**Historical Architectural Review Board  
COA Final Review Sheet**

**HDC-2023-00096**

**Address: 503 W. Allen Street**

**Proposal: Replace second-story windows and framing**

Front façade with windows removed and boarded, 2023.  
(Applicant)

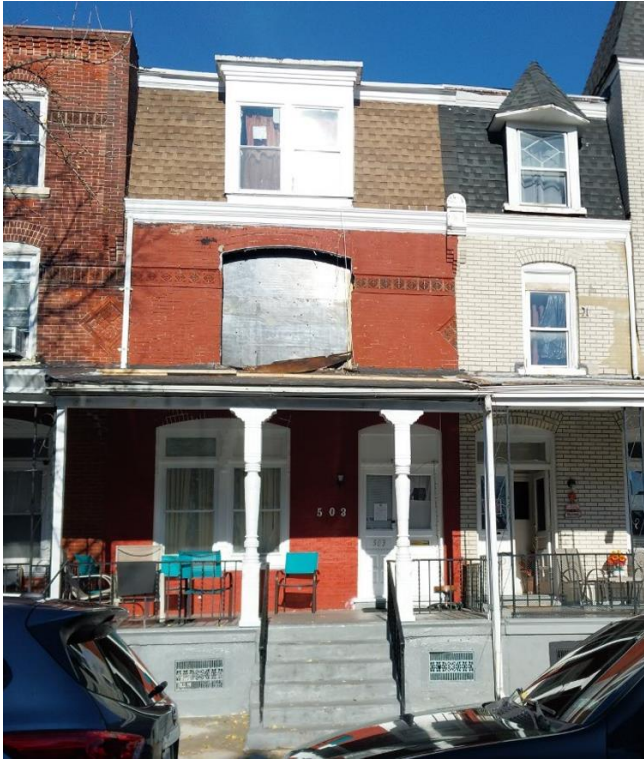
At the time the applicant submitted the application, the second-story windows and framing had been removed without permits or a certificate of appropriateness. The drawing included in the application shows the interior framing and proposed window replacement. Staff initially rejected the drawing and requested an exterior drawing showing the framing and masonry opening; however, the applicant again provided the same drawing of the interior framing. Staff finds that the HARB cannot properly review the proposed scope of work without a drawing that shows the exterior framing, noting that the decorative trim below the lintel and the center mullion have been removed and should be recreated to their original dimensions and appearance to comply with Guideline 3.5.15.

Staff further notes that the façade has paint and roofing tar on the brick that should be removed to bring the property into compliance.

Denial, owing to incompleteness, with the comment that a scaled elevation drawing of the exterior framing, trim, and masonry opening be submitted for HARB review.

- The exterior trim will be 1” thick, flat, rot resistant wood (not pressure-treated and not capped in aluminum)
- The sill will be a 4”-5” above the roof surface to the bottom and would be appropriately flashed from under the sill to the roof.
- The sill would be 3”-4” thick and made of rot resistant wood (not pressure treated and not capped in aluminum).
- The carved arched header piece will be reinstalled.
- The unique “keystone” details will be replicated.
- The window replacements are aluminum clad wood as proposed.

Proposed aluminum clad window.  
(Applicant)

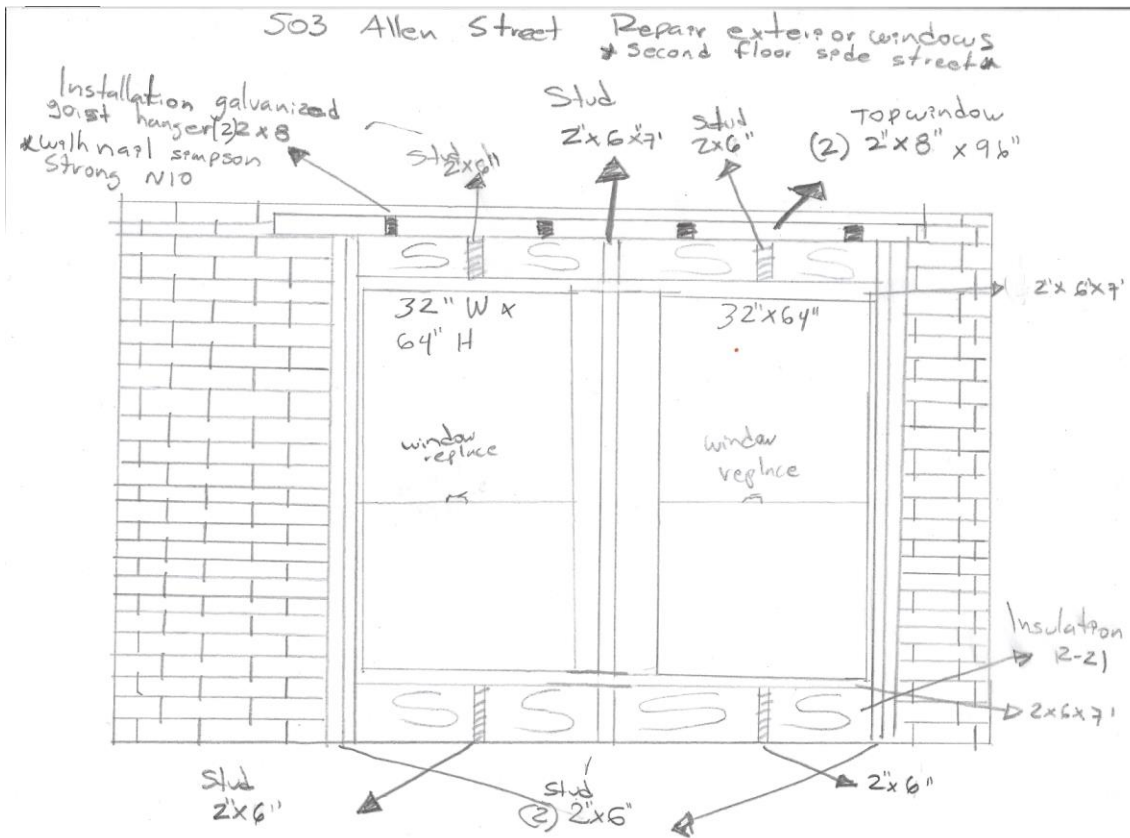
If all exterior framing and trim is replicated to match the historic, staff finds the proposed aluminum-clad wood sash windows to be appropriate, provided they are the same dimensions as the historic windows.
